ANCHOR BOLT SETTING PLAN

PROJECT OWNER : CK CAPITAL, LLC
PROJECT DESCRIPTION : CLEVELAND BROTHERS-MILESBURG
PROJECT ADDRESS : 1025N. EAGLE VALLEY ROAD, HOWARD, PA 16841
CONTRACTOR : KINSLEY CONSTRUCTION, INC.

DRAWN BY : BAS	DATE : 5-20-25	PROJ. NO. : 25012	REV # A
CHECKED BY : SRP	DATE : 5-20-25	DWG NO. : AB01	
DWG DESCRIPTION : ANCHOR BOLT SETTING PLAN

1 / AB01

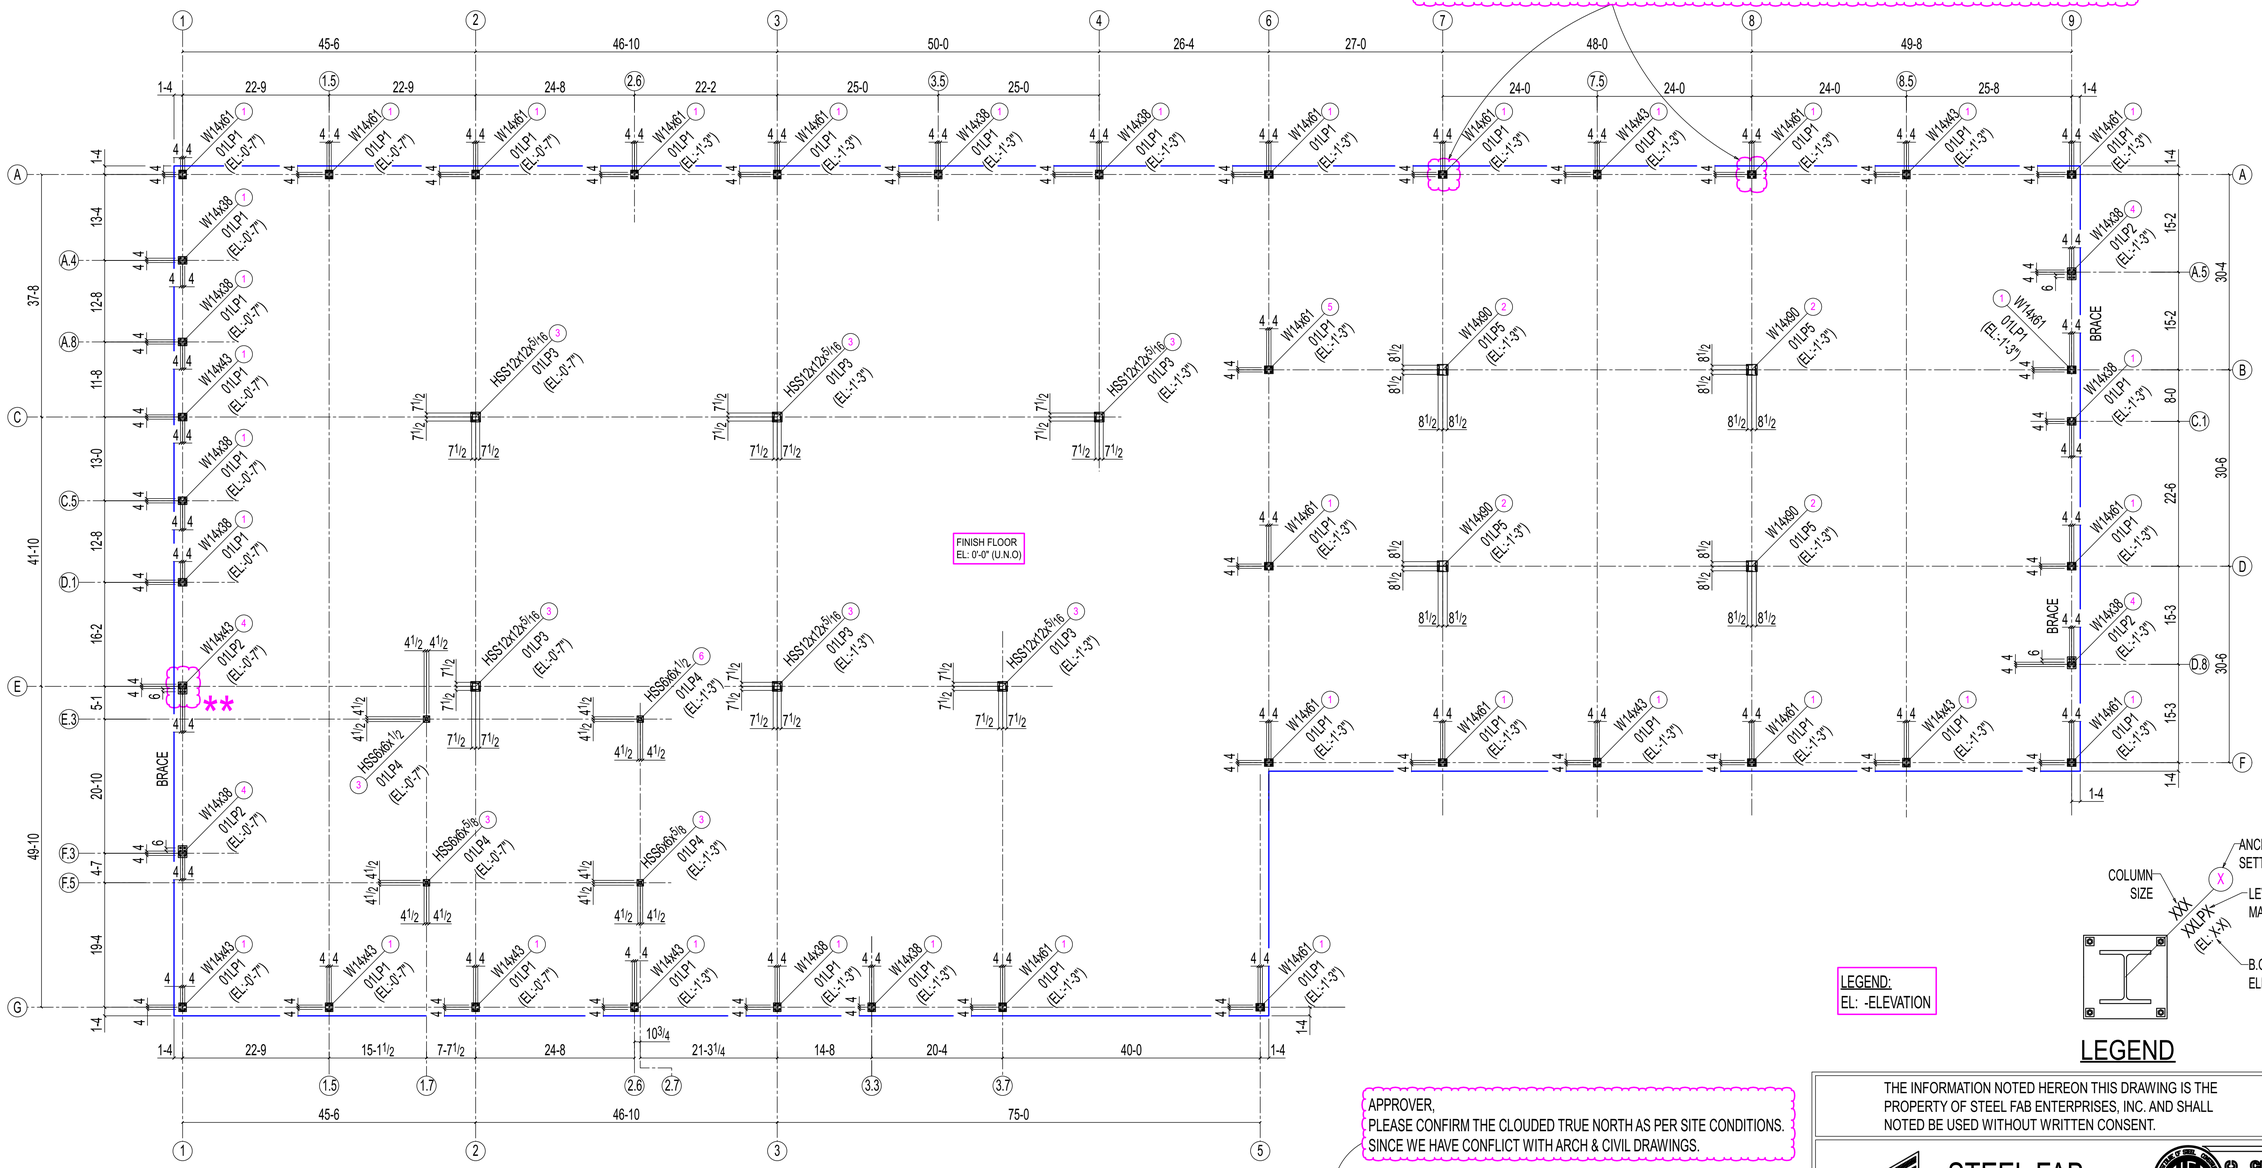
APPROVER,
PLEASE CONFIRM THE ORIENTATION OF THE CLOUDED COLUMNS. THE ARCHITECTURAL DRAWINGS SHOW THE COLUMN WEB ALIGNED PARALLEL TO GRIDS 7 & 8, WHILE THE STRUCTURAL DRAWINGS INDICATE THE WEB IS PARALLEL TO GRID A. ACCORDINGLY, WE HAVE PROCEEDED WITH THE COLUMN WEB ORIENTATION PARALLEL TO GRID A, AS PER THE STRUCTURAL DRAWINGS. PLEASE CONFIRM IF THIS OK TO PROCEED?

APPROVER,
PLEASE CONFIRM THE CLOUDED TRUE NORTH AS PER SITE CONDITIONS. SINCE WE HAVE CONFLICT WITH ARCH & CIVIL DRAWINGS.

** -APPROVER,
WE NEED TO EXTEND OUR BASEPLATE FOR VERTICAL BRACE'S BOTTOM CONNECTION AS SHOWN IN SECTION 9 /201 & 4/AB02 AND DUE TO BASE PLATE EXTENTIONS,CONTRACTOR TO EXTEND THE PIER FOR 1-9 TO SOUTH FROM GRID 'E' IN LIEU OF EXTENTING 1-9" TO NORTH FROM GRID 'E' AS GRAPHICALLY SHOWN IN STRUCTURAL FOUNDATION PLAN S101.

PLEASE CONFIRM & COORDINATE WITH OTHER TRADES.
